Access Compliance Report

Public Rights-of-Way

(Pedestrian Signals)

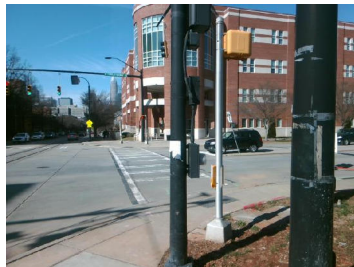
PROW/ADA: TMUTCD 4e.08, R404.2, R404.3, R406.2, R404.7.3, R209.1, MUTCD 4e.10

Possible Solutions: Replace Signal Push Button With APS Button on New Post. Remove & Relocate Sign.
